Wollongong Local Planning Panel Assessment Report | 9 August 2022

WLPP No.	Item No. 3
DA No.	DA-2021/1355
Proposal	Residential - demolition works, removal of two trees, alterations to existing dwelling, construction of an additional dwelling to form a dual occupancy and Subdivision - Torrens title - two (2) lots
Property	18 Seaview Crescent Stanwell Park
Applicant	MJD Design & Drafting
Responsible Team	Development Assessment and Certification - City Wide Team (NA)
Prior WLPP meeting	N/A

ASSESSMENT REPORT AND RECOMMENDATION

Figure 1 – Northern Elevation of Dwelling 1 showing amended roof form.

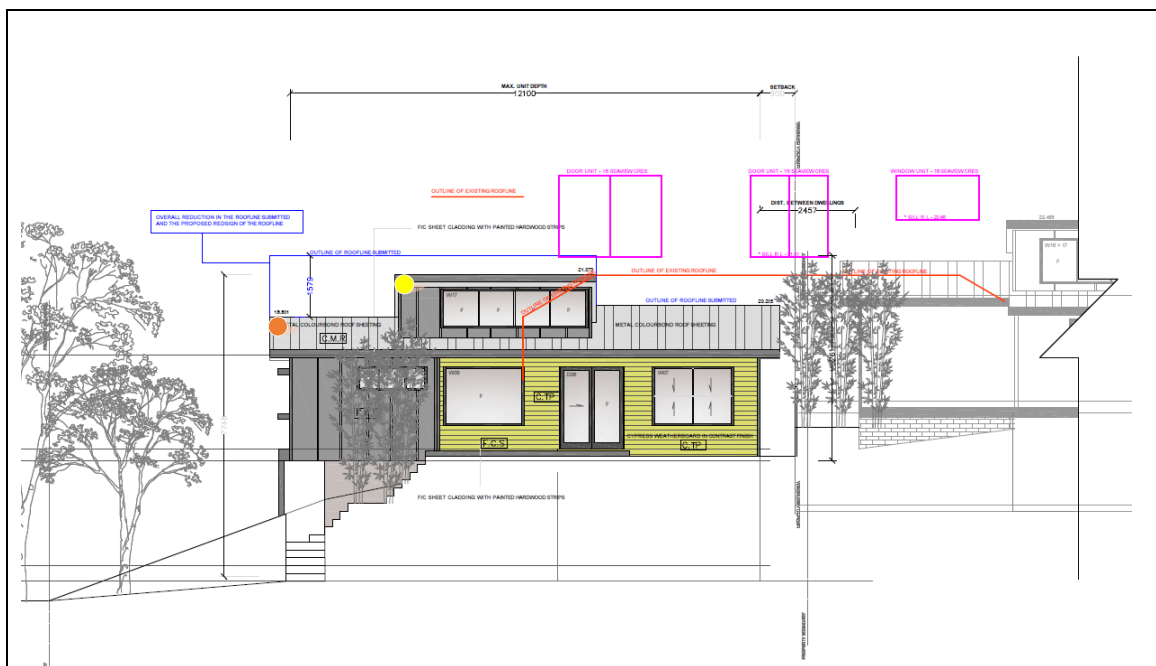
It is considered that changes to the roof pitch would result in improved view sharing outcomes for the adjoining property. The roof should be changed to provide for increased view sharing with the adjoining property in this regard.

Following neighbour notification and prior to receipt of Council's letter, the landowner acknowledged the concerns raised by their neighbour in relation to view impact and began working to find an alternate roof form for Dwelling 1. Amended plans have been prepared with a notably reduced roof form and this report is based on the modified design prepared by MJD Design & Drafting. To the front of Dwelling 1 the roof form has been reduced by 1.579m to the easternmost skillion roof and by 487mm to the central skillion roof incorporating northern highlight windows. The below image is provided in the updated set of plans and demonstrates:

- the modified roof form submitted for consideration;
- blue line indicating the roof form on the original DA plans;
- red line indicating the roof line of the existing dwelling as a reference point;
- purple doors/windows relate to the surveyed level of the southern openings of the adjoining dwelling at No. 16.

As noted in Figure 1, the proposal as modified results in a reduced roof form to the front of Dwelling 1. The development maintains a reduced ridgeline through the middle of the site and maintains a new corridor of 2.373m through the centre of the site between the proposed dwellings.

Fig.6 – 3D render of proposed development, sited using survey levels of existing built features of the subject and adjoining sites.

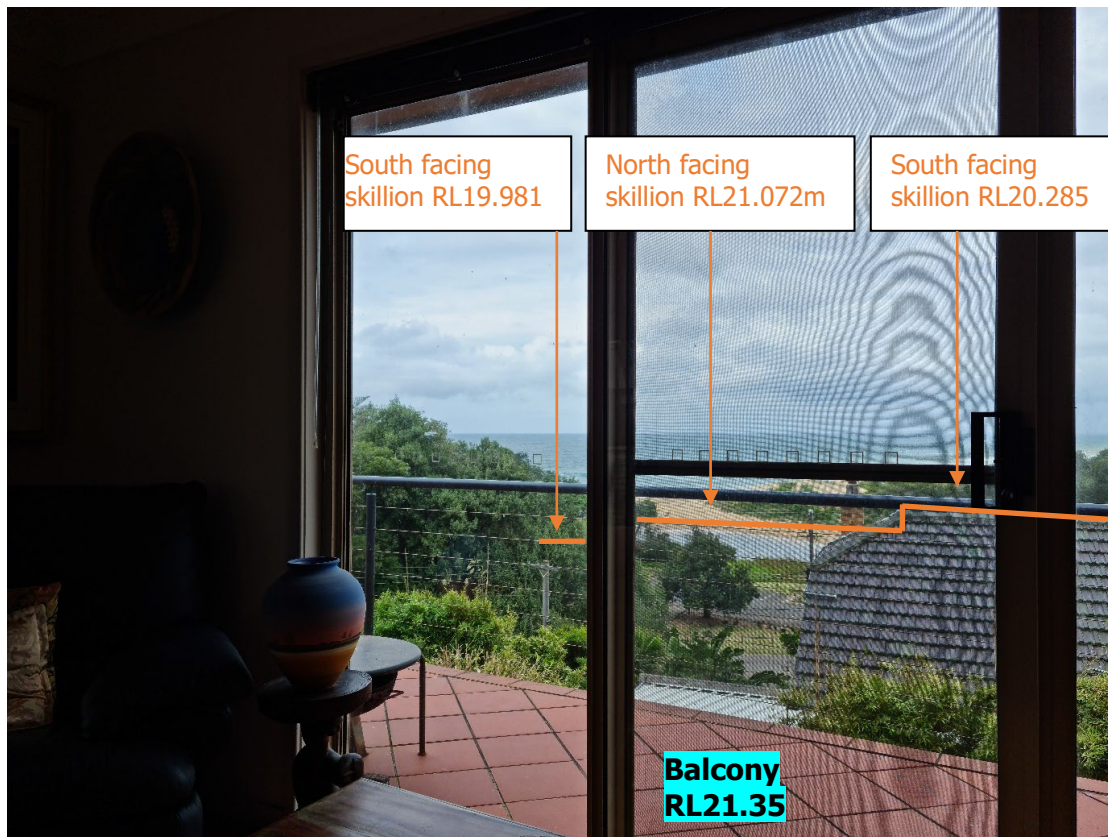
The existing siting of No. 16 & No. 18 Seaview Crescent is best demonstrated in Figures 4 & 5 below relating to an aerial image (Fig.5) taken from Stanwell Park beach looking north-west toward the properties. Figure 4 identifies the location the photo was taken from in context to the sites.

A firm was engaged to prepare a 3D architectural render of the proposed development over the same image taken from Stanwell Park beach. The 3D render was placed over the image utilising survey levels of the existing dwelling, RL's of No. 16, along with RL's of the proposed rooflines. The 3D image provided is shown below in Figure 6 and provides a representation as to where the new development will be located in relation to No. 16. As this image is taken from the beach it demonstrates the extent to which the existing and proposed dwellings impact upon the openings in the southern elevation of No. 16.

The level of water views retained is considered to be substantial for a view obtained across a side boundary, well exceeding many previous view sharing outcomes. The 3D render in Figure 6 demonstrates that the reduced roof form proposed within this development, allows for No. 16 to retain far greater views than properties further north have been afforded.

Figure 14 – North Elevation showing height from key ridge points to existing ground level directly below.

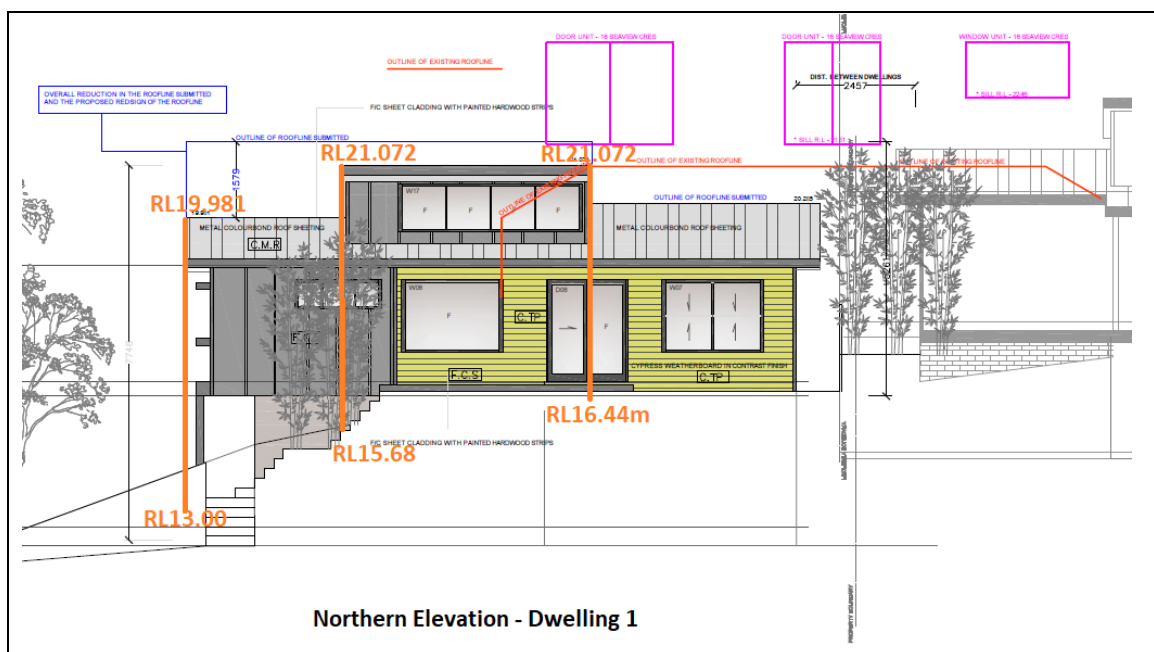
The dwelling remains substantially below the 9m height allowance. While the landowner has willingly agreed to lower the roof form to the front of Dwelling 1 to reduce the impact on views, both the original and proposed dwelling heights are considered to be most reasonable. The original roof height in the area of the clerestory windows was a maximum of 5.879m, with the modified design now providing a maximum height of 5.392m. The height above natural ground for Dwelling 1, in the 3 main areas of consideration in relation to views, are shown in Figure 14 below:

The proposed dwelling heights are considered extremely modest for a sloping site in this area and well below the height of many surrounding and directly adjoining dwellings. The purpose of the clerestory windows is to provide light into the dwelling and to gain northern solar access, ensuring a high level of energy efficiency as encourage by the solar access objectives within Wollongong Development Control Plan 2009. A high degree of consideration has been given to appropriately integrating the dwelling within the landform and streetscape while minimising impacts on neighbours.
